**BEFORE  
THE PUBLIC SERVICE COMMISSION OF  
SOUTH CAROLINA**

**DOCKET NO. 2019-226-E**

South Carolina Energy Freedom Act (House Bill 3659) Proceeding Related to S.C. Code Ann. Section 58-37-40 and Integrated Resource Plans for Dominion Energy South Carolina, Incorporated

**JOINT COMMENTS OF SOUTH CAROLINA COASTAL CONSERVATION LEAGUE, SOUTHERN ALLIANCE FOR CLEAN ENERGY, CAROLINAS CLEAN ENERGY BUSINESS ALLIANCE, AND SIERRA CLUB**

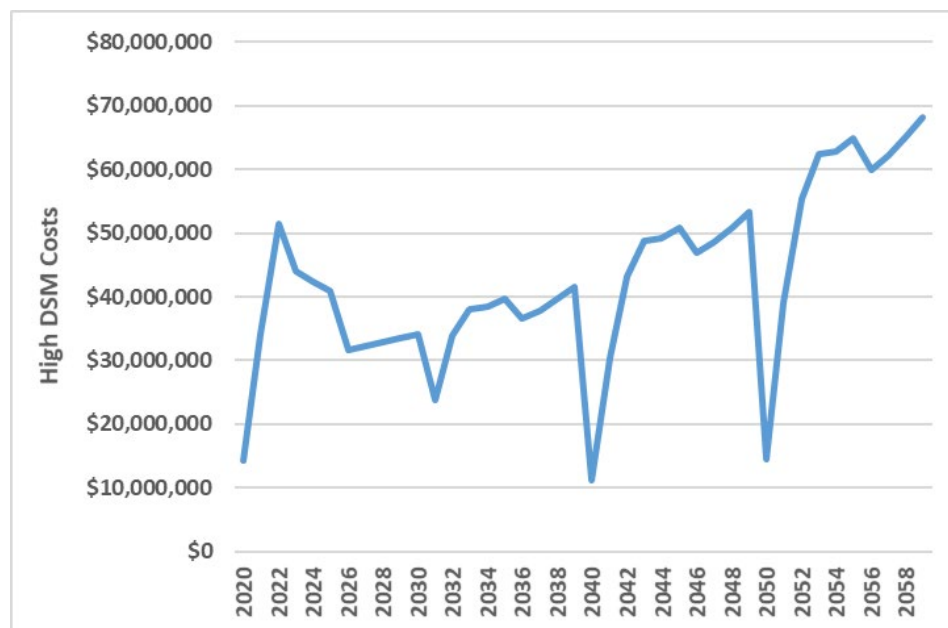
First, the EE profile—like the Company's overall load profile—should show a clear diurnal pattern and weekday vs. weekend pattern. But the EE profile does not show any of this expected variation, nor does it align with the load profile at all. In fact, the EE profile experiences its peak value in an entirely different season and month than DESC experiences its summer peak or (more infrequent) winter peaks. And despite DESC experiencing much more frequent summer peaks, its EE profile shows more savings overall in the winter time, which is counterintuitive.

Second, DESC's EE profile relies on a weighting metric, in which over half of its EE savings are from a "central lighting control" measure that is not a dominant component of its EE portfolio.

Finally, and most confusingly, DESC's EE profile shows frequent *negative* savings in its shape; in other words, the profile shows that EE measures *increase* energy usage during several months of the year. For example, two of the EE measures that most heavily contribute to the negative savings in the EE profile, Furnace/AC - SEER 16 measures, show net negative savings for half the year. Because this is a SEER 16 measure, which exceeds even the upcoming 2023 change to the minimum required efficiency for central AC units, it could not possibly be the case that this measure would replace a unit that is somehow *more* efficient during the summer thus resulting in more energy consumed

by the SEER 16 measure. Indeed, if that were the actual net effect of DESC's rebate for central AC/furnace measures it would be an indicator of fatally flawed program design.
